South Texas Project Electric Generating Station P.O. Box 289 Wadsworth, Texas 77483

February 12, 2018  
NOC-AE-18003541  
10 CFR 50.90  
10 CFR 50.54(q)  
File No. G25

South Texas Project  
Units 1 and 2  
Docket Nos. STN 50-498, STN 50-499  
Response to Request for Additional Information for the  
License Amendment Request for Revision to Staffing and Staff Augmentation Times in the  
South Texas Project Electric Generating Station Emergency Plan  
(TAC Nos CAC MG0024, MG0025)

**Response to Request for Additional Information  
Related to License Amendment Request for Emergency Plan Change**

**FIGURE C-1**

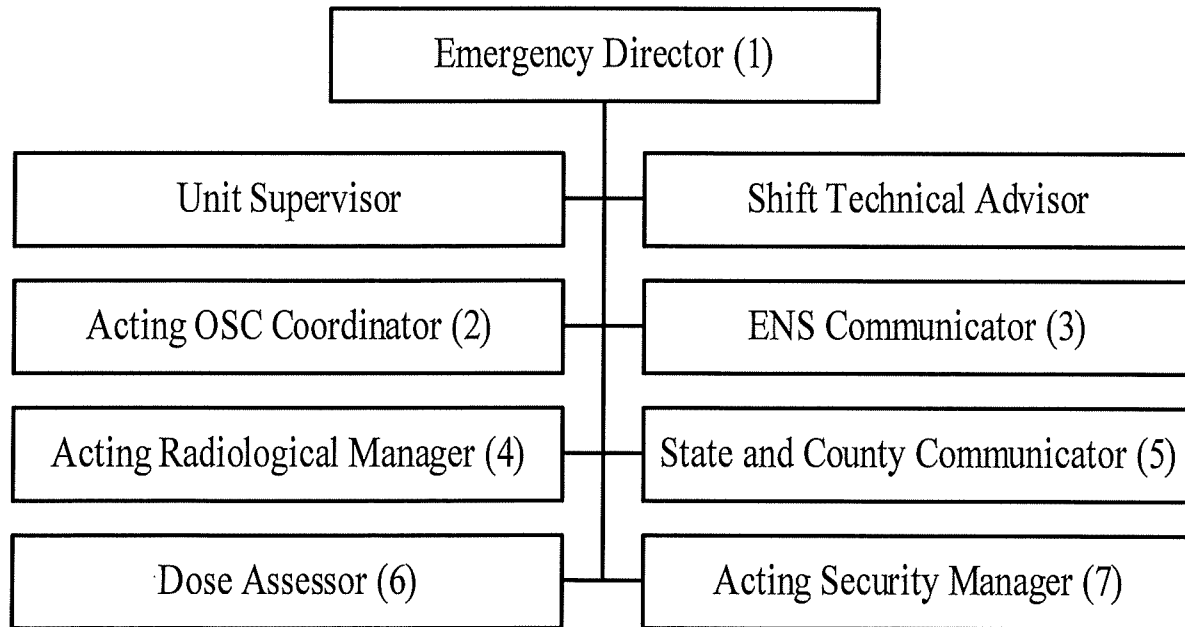
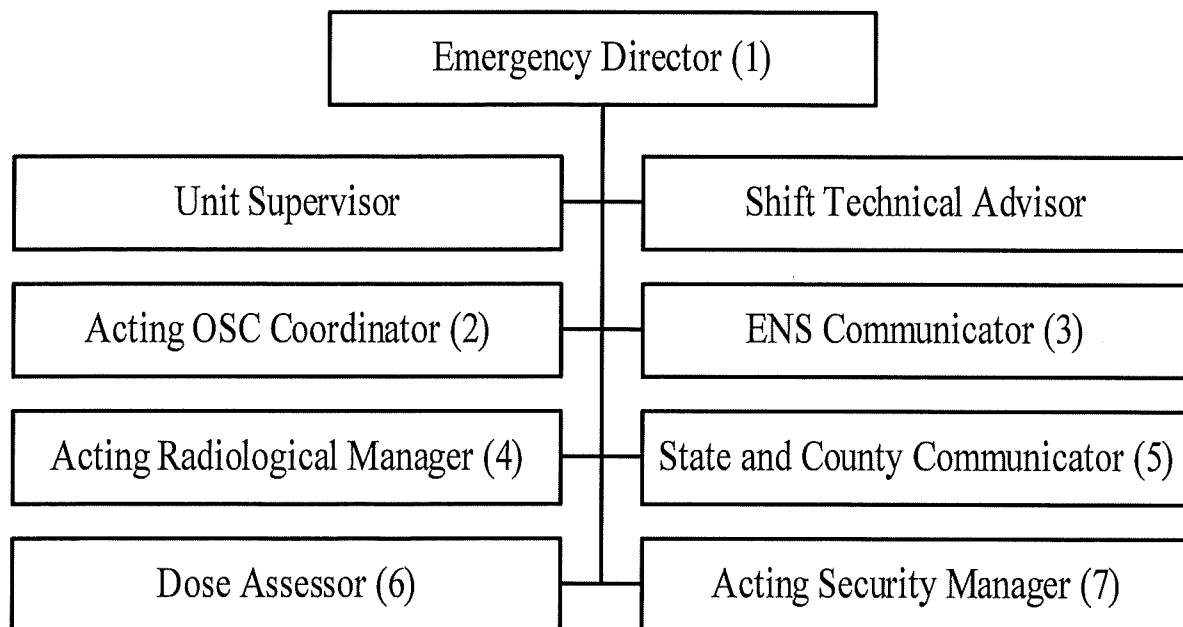
The proposed STPEGS Emergency Plan provides that dose assessment will be performed by a qualified on-shift individual, who may be the Acting Radiological Manager. The NRC staff could not determine who would perform this function or what conditions would preclude the Acting Radiological Manager from performing dose assessment.

Please explain what conditions, if any, would preclude the Acting Radiological Manager from being able to provide dose assessment. For these conditions, please explain who will provide dose assessment, and explain why this position was not included on Table C-1.

Note 1 on proposed Table C-1 is being modified to read, "The Dose Assessor is filled by the Acting Radiological Manager". See Attachments 1 and 2 to the Enclosure for updated marked up and clean copies of proposed Table C-1. In addition, Note 6 for the Dose Assessor on proposed Figure C-1 is being modified to read, "Qualified individual filled by Acting Radiological

Manager.” See Attachments 3 and 4 to the Enclosure for updated marked up and clean copies of proposed Figure C-1.
